<b>ITEM: 6.9</b>	<b>COMMITTEE OF ADJUSTMENT REPORT SUMMARY MINOR VARIANCE APPLICATION FILE NUMBER A095/23 73 ALISTAIR CRESCENT, KLEINBURG</b>
------------------	--

**COMMITTEE OF ADJUSTMENT REPORT  
MINOR VARIANCE APPLICATION  
A095/23  
73 ALISTAIR CRESCENT, KLEINBURG**

<b>ITEM NUMBER: 6.9</b>	<b>CITY WARD #: 1</b>
<b>APPLICANT:</b>	Stephanie Criminisi
<b>AGENT:</b>	AG Design
<b>PROPERTY:</b>	73 Alistair Crescent, Kleinburg
<b>ZONING DESIGNATION:</b>	See below.
<b>VAUGHAN OFFICIAL PLAN (2010) DESIGNATION:</b>	Vaughan Official Plan 2010 ('VOP 2010'): "Natural Areas" by Volume 2, Area Specific Policy 12.7, Block 61 West - Nashville Heights
<b>RELATED DEVELOPMENT APPLICATIONS:</b>	None
<b>PURPOSE OF APPLICATION:</b>	Relief from the Zoning By-law is being requested to permit a covered porch/deck at the rear of the existing dwelling.

DATE: 03/20/2023	DRAWING NO.:
SCALE: As indicated	A2
DRAWN BY: AG	
	2267

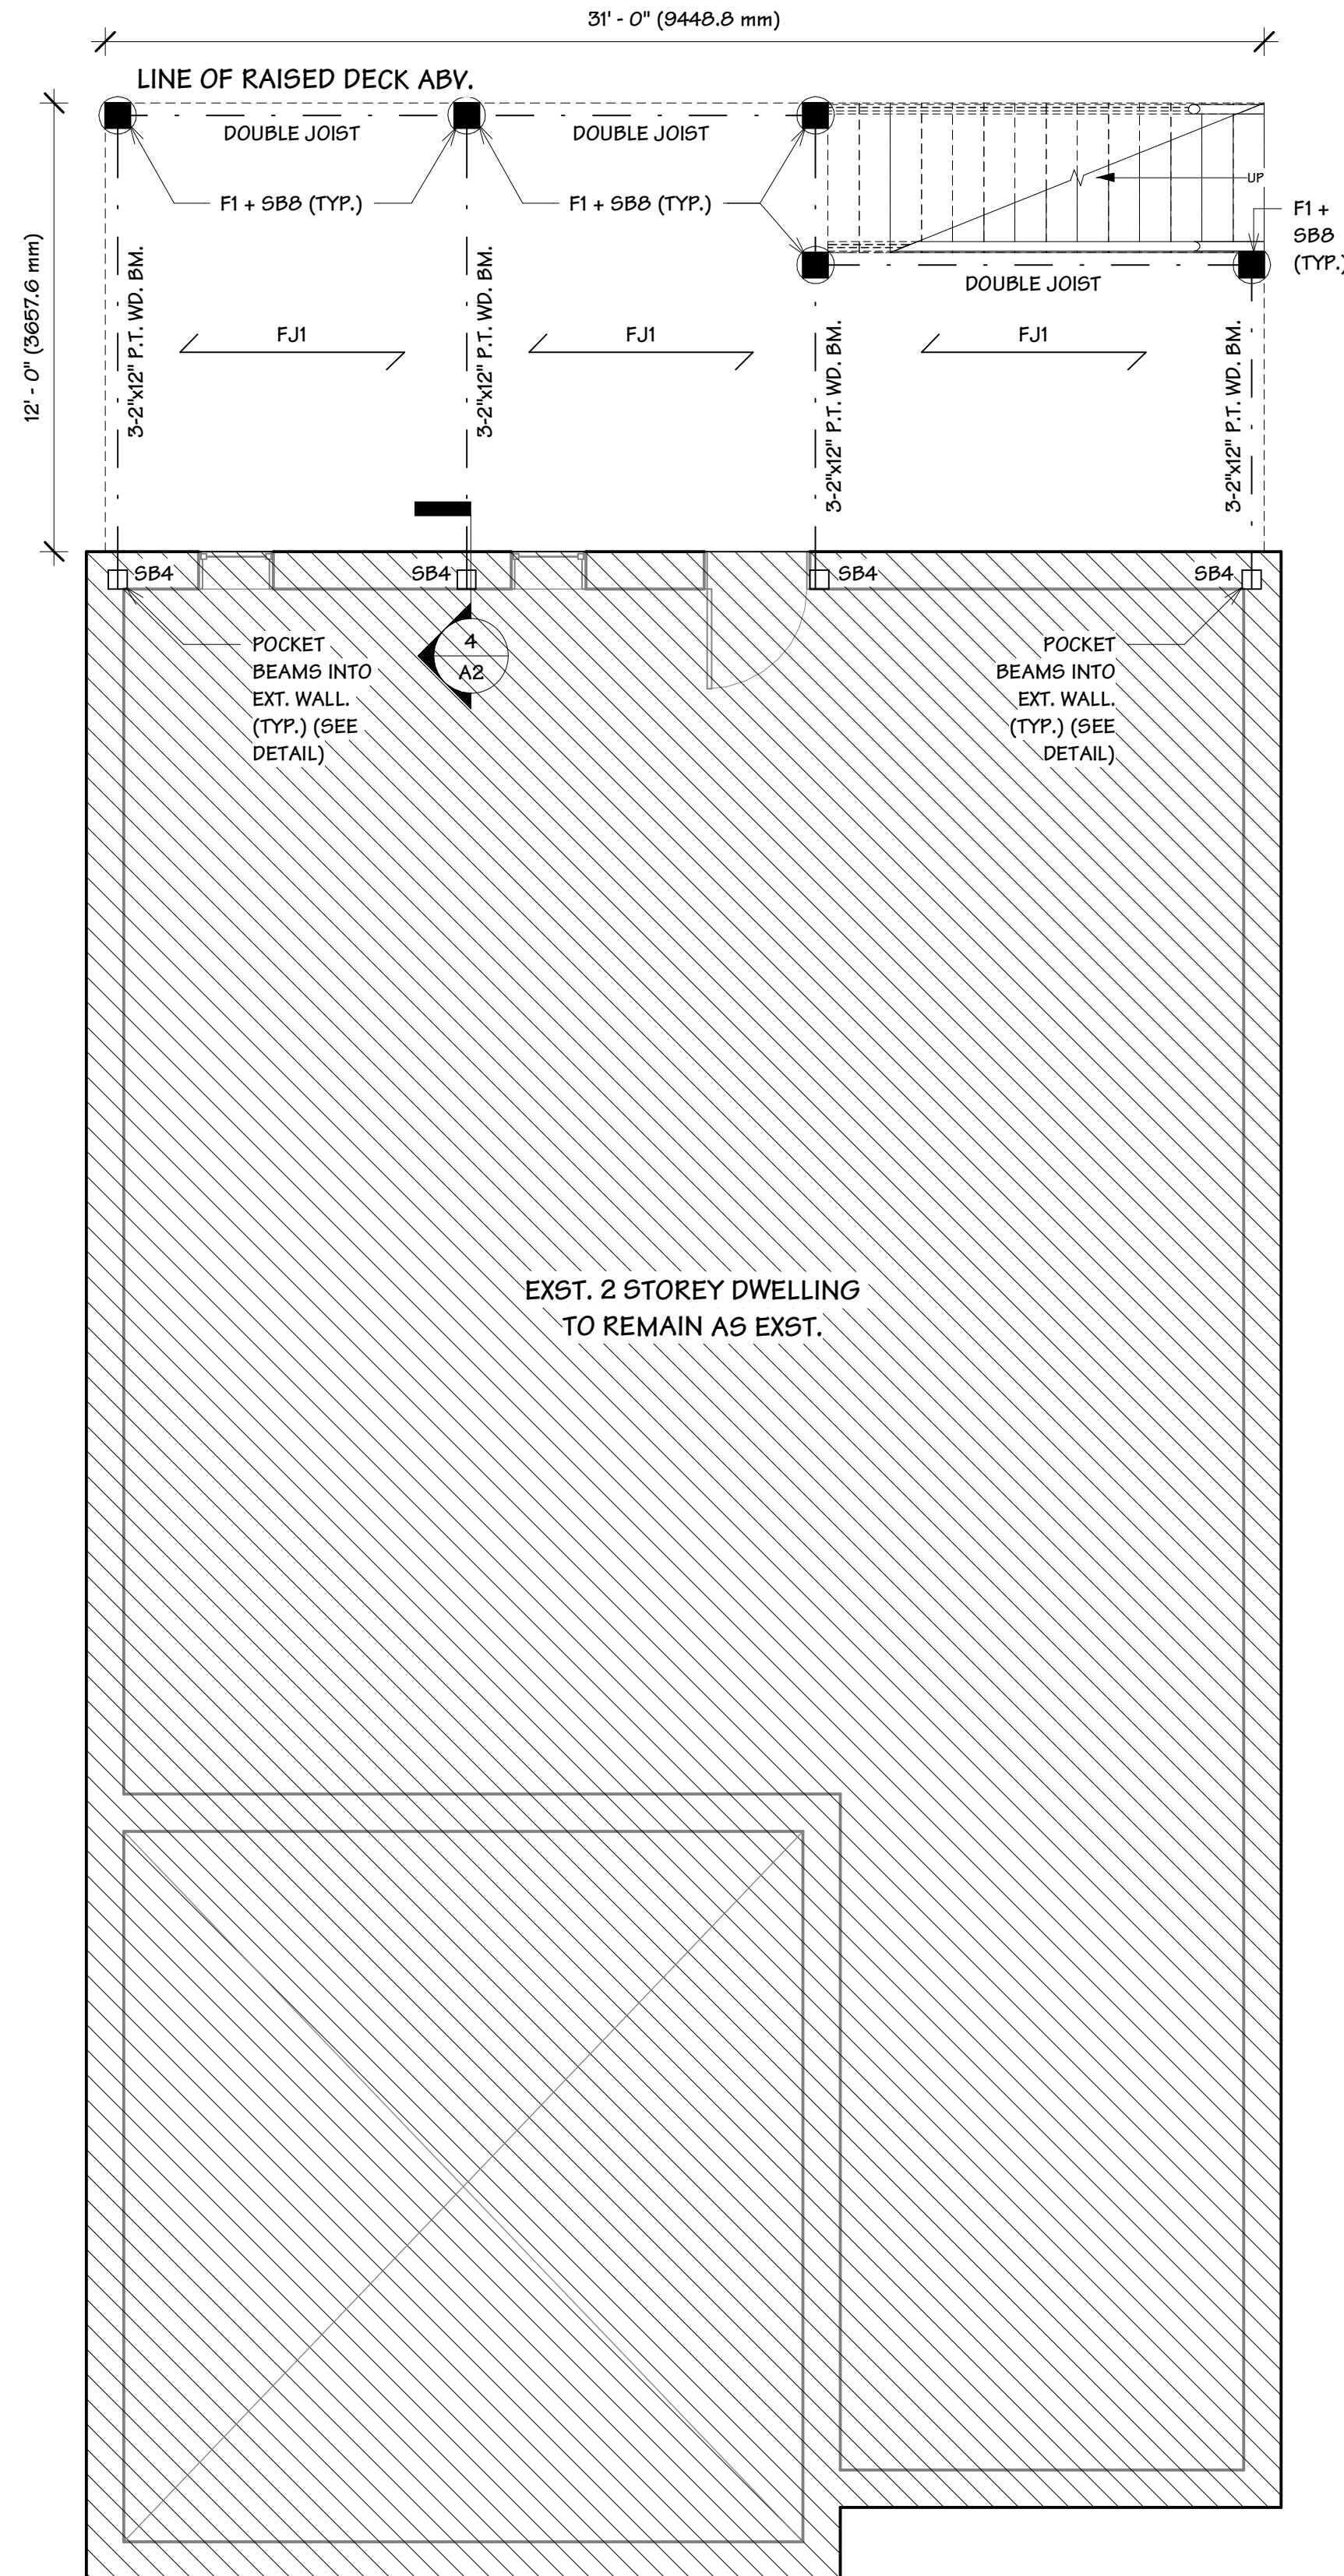
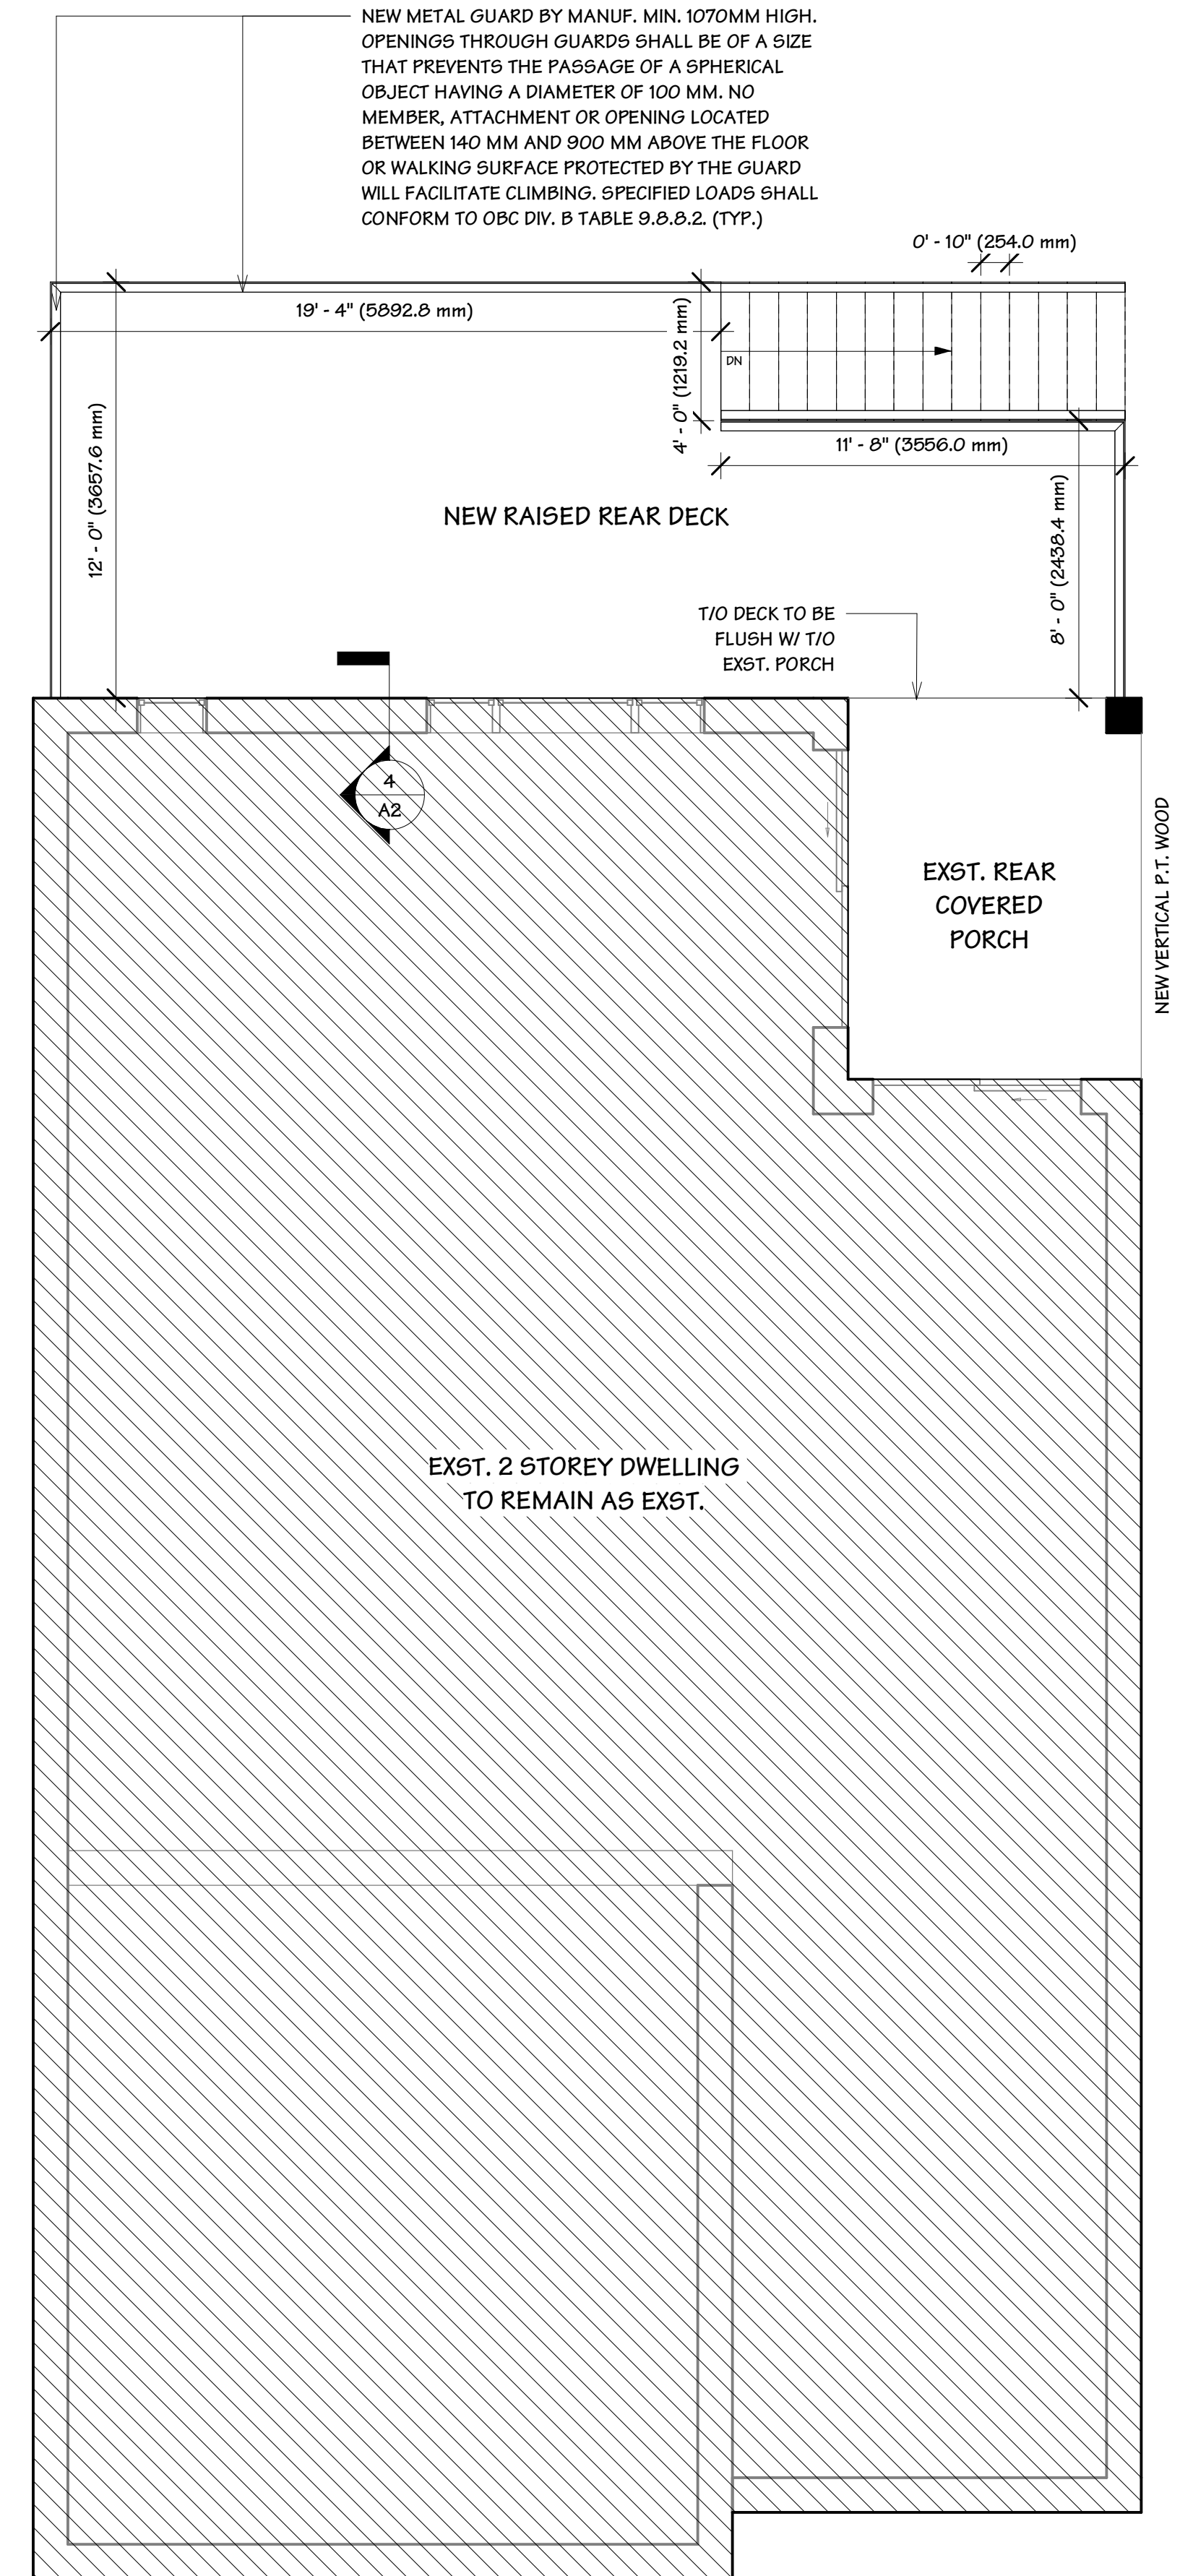
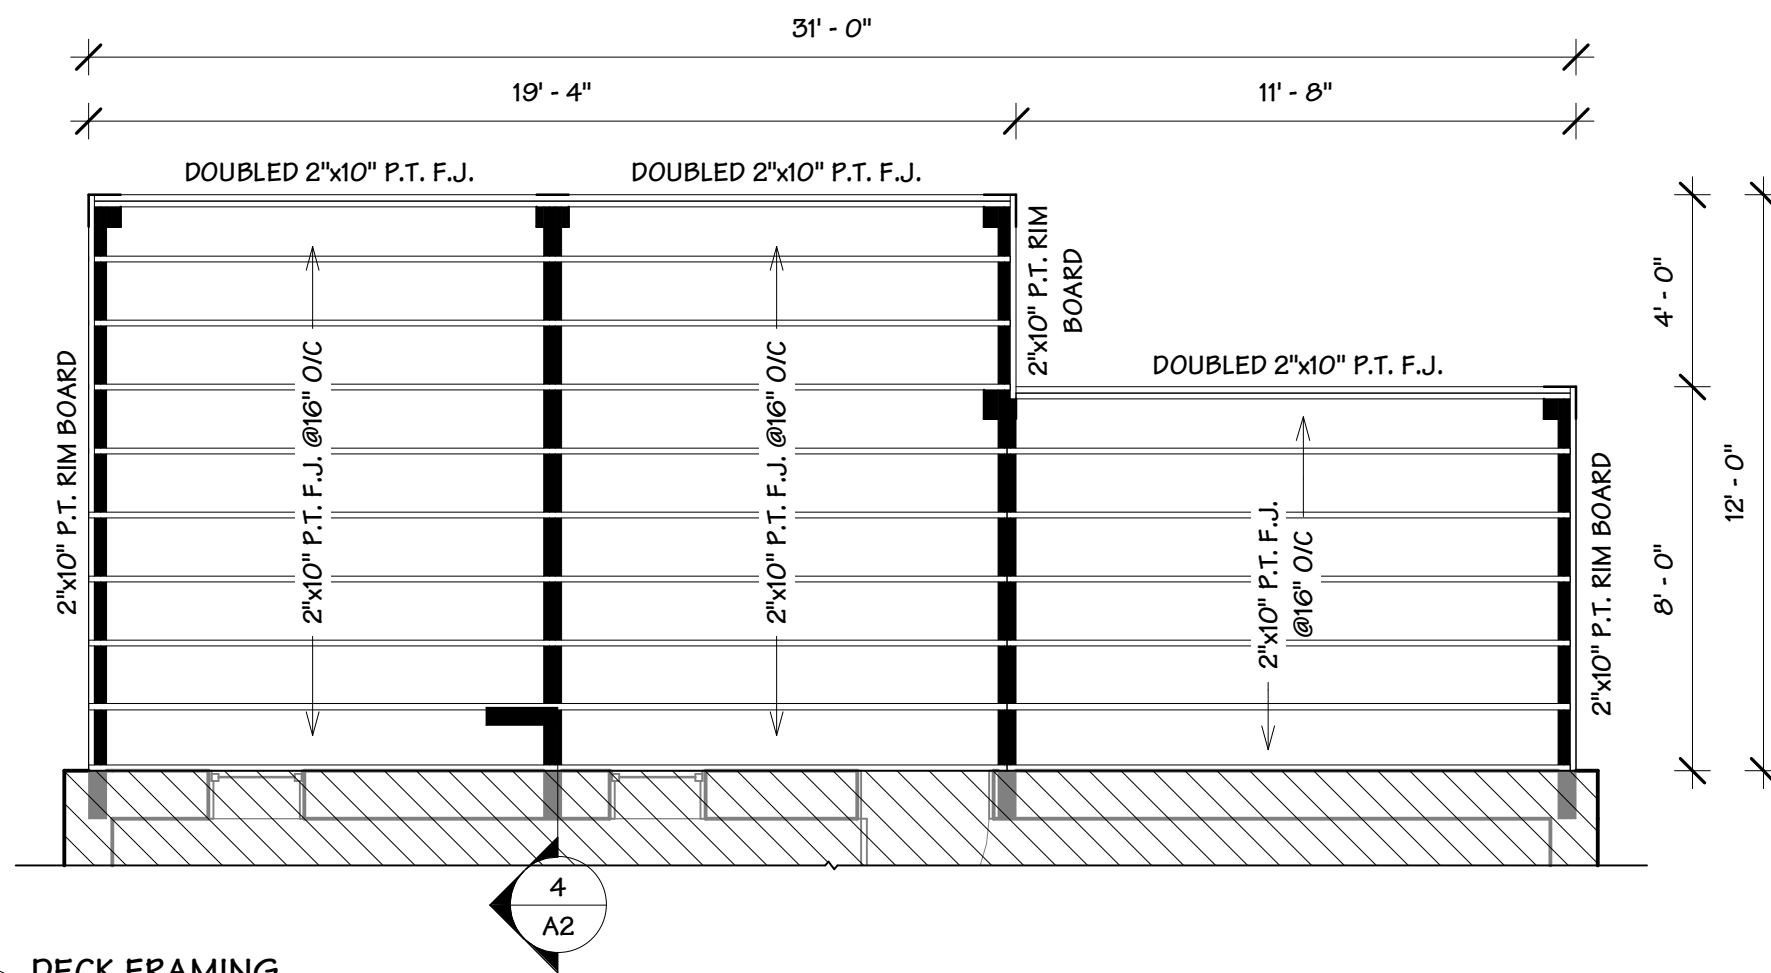
The Development Planning Department has no objection to the proposed variance for the elevated deck. The deck is proposed above a walk-out basement and will facilitate access between the main floor and rear yard. The stairs, located to the southeast, are incorporated into the deck's footprint and will not further project into the rear yard. The incorporation of the stairs into the deck footprint will reduce the mass and useable deck space facing the south and east lot lines. The property also backs onto an open space zone. As such, the development will not pose any adverse use or massing impacts to the abutting properties.

Accordingly, the Development Planning Department can support the requested variance and is of the opinion that the proposal is minor in nature, maintains the general intent and purpose of the Official Plan and Zoning By-law, and is desirable for the appropriate development of the land.
